CEL MN-ED-DD (ED-SP/17 OCT 89) 1st End ✓ Desai/cm/2657
SUBJECT: Lk Pont, LA & Vic, 17th St. Canal Parallel Flood Protec-
tion, Phase 1B-Hammond Hwy. to So. Railroad, OLD Project No.
2043-0207

Subject: Lake Pontchartrain La & Vic ALP 17th Street Canal
Parallel Flood Protection Phase 1B Hammond Highway To Southern
Railroad OLB Project NO. 2043-0207

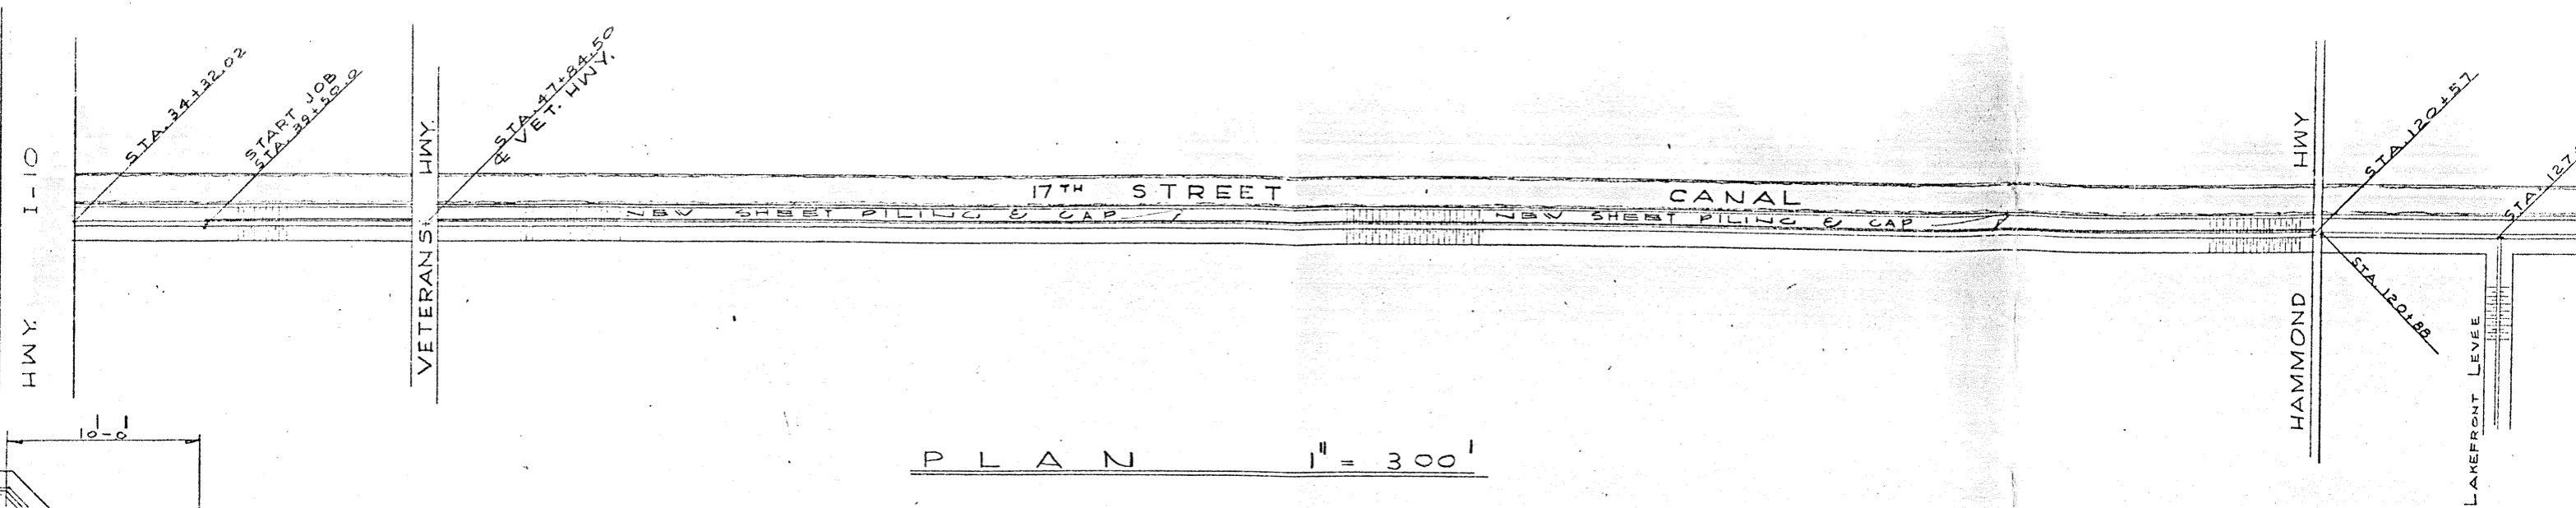
As I mentioned in our telephone conversation last week, we have discovered that due to the most recent changes in sheet pile design criteria for the Lake Pontchartrain Flood Protection Plan, it may now be possible to reuse some of the existing sheet pile on the Orleans levee of the 17th Street Canal for the High Level Flood Protection Plan. According to the enclosed drawing, dated 1964, the existing sheet pile on the Orleans levee between Hammond Highway and a point south of Veterans Highway is copper bearing, type M-115, and has a length of 20'. (The specifications for this type of sheet pile are enclosed.)

We are proposing to have the Contractor pull sheet pile from the area defined above and reuse some of it between Stations 627+28 and 638+31 and between Stations 643+00 and 670+62.9. Only about one-half of the existing sheets will need to be reused. Those that are, will of course be blasted and coated along the required length.

Our calculations show that type M-115 sheet pile has an adequate section modulus, based on an allowable stress of $0.45F_y$, to resist the design bending moments specified in Eustis' geotechnical analysis (31 August 1988). In addition, the deflection obtained by using the pressure diagram resulting from a factor of safety of 1.0 applied to the Q-case soil strengths with a high water level 2 feet above SWL is well under the allowable 1.5 inches.

We do not have any objections to reusing the existing sheet piling, provided our October 21, 1988, comments are resolved to satisfy Lake Pontchartrain, Louisiana and Vicinity Hurricane Protection, Project, High Level Plan, design criteria.

DETAIL A

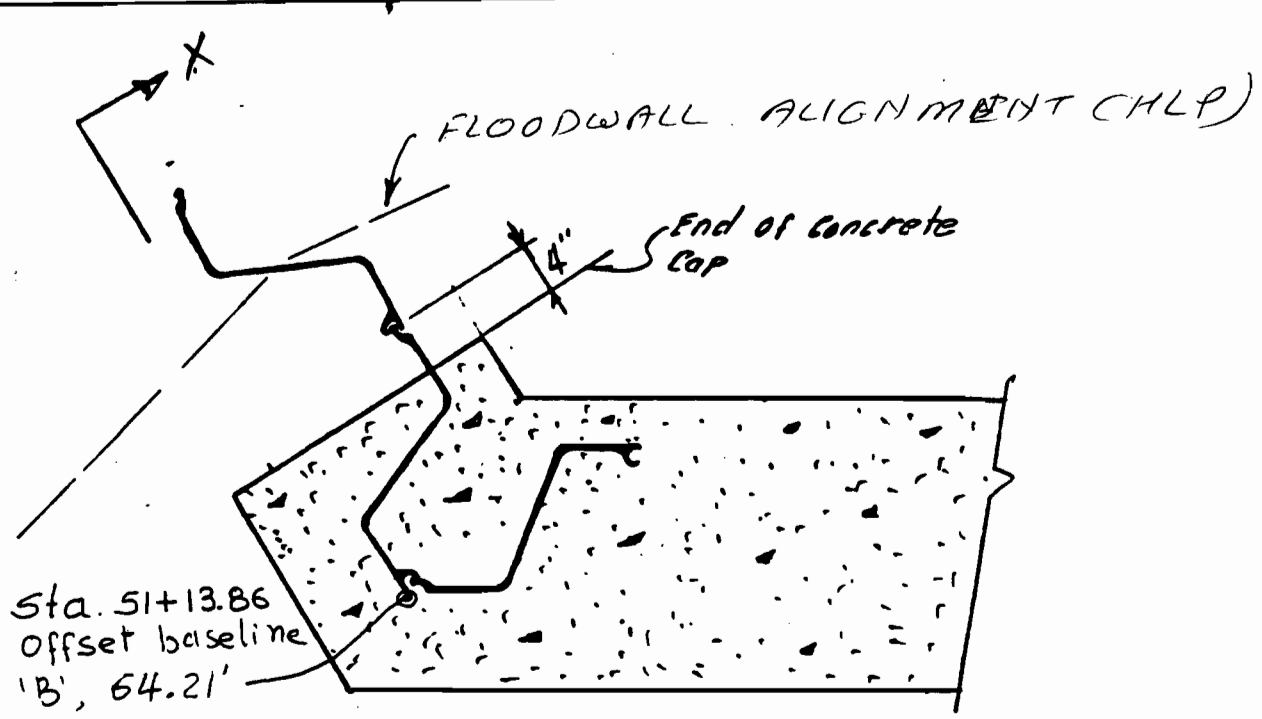
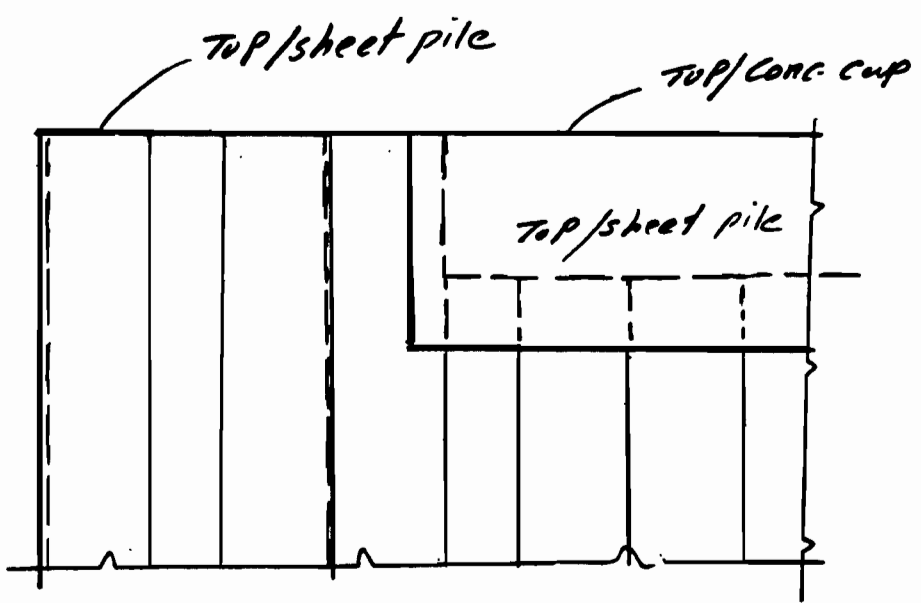
The design of the toe-wall is satisfactory. However, we recommend that the end of the concrete cap be revised as shown on the attached sketches. This revision is required to facilitate transitioning the proposed flood protection at the pumping station into the floodwall along the east bank of the canal to be constructed under the Lake Pontchartrain, Louisiana and Vicinity Hurricane Protection Project, High Level Plan.

STA. 625+00 TO STA 635+00
ORLEANS SIDE

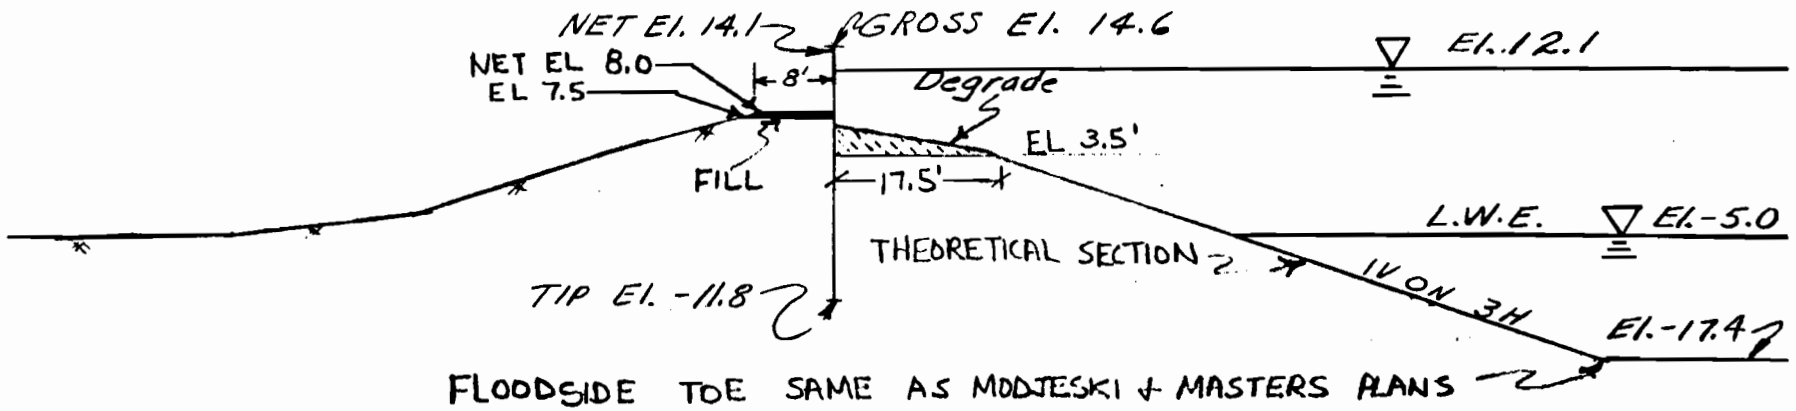
c. Station 625+00 to Sta. 635+00. Our preliminary analysis indicates that a lower tip penetration of the sheet piling than the penetration shown on the plan is required to satisfy the floodwall stability into the canal.

d) The sheetpile tip elevation between Sta. ⁶²⁵⁺⁰⁰~~614+00~~ to Sta. ⁶³⁵⁺⁰⁰~~625+00~~ should be lowered based on a cantilever retaining wall analysis to be performed to the floodside for the section presented in the plans.

STA 663+00 TO STA 670+00
ORLEANS SIDE

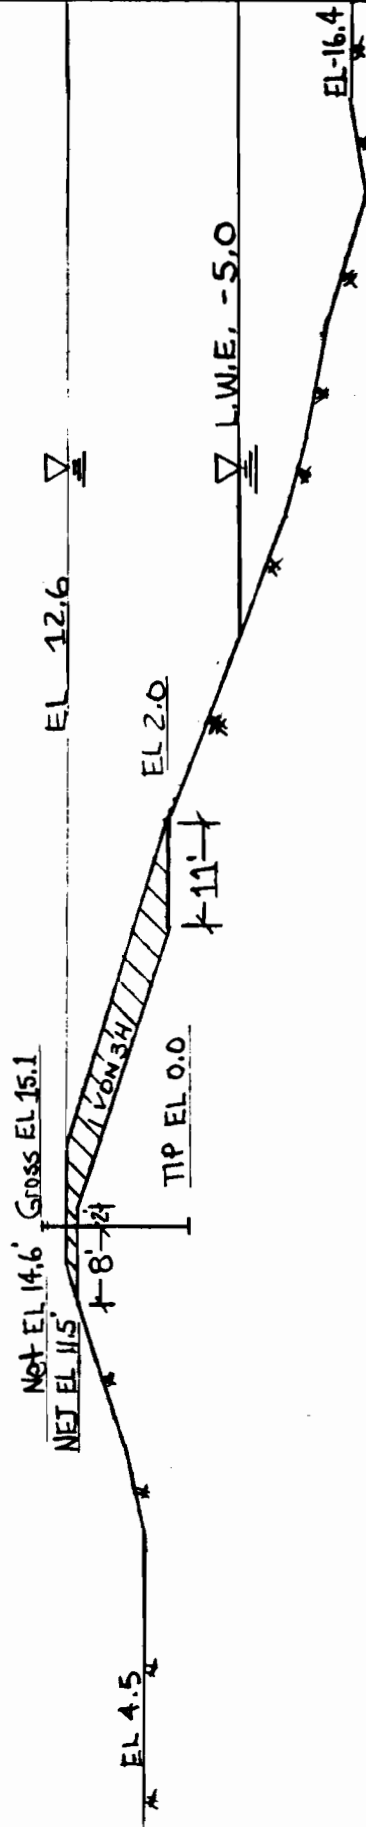
c) Furnished is a revised design section for Sta. 663+00 to Sta. 670+00, Orleans Parish side, based on the sections shown in the preliminary plans. See encl. 2.
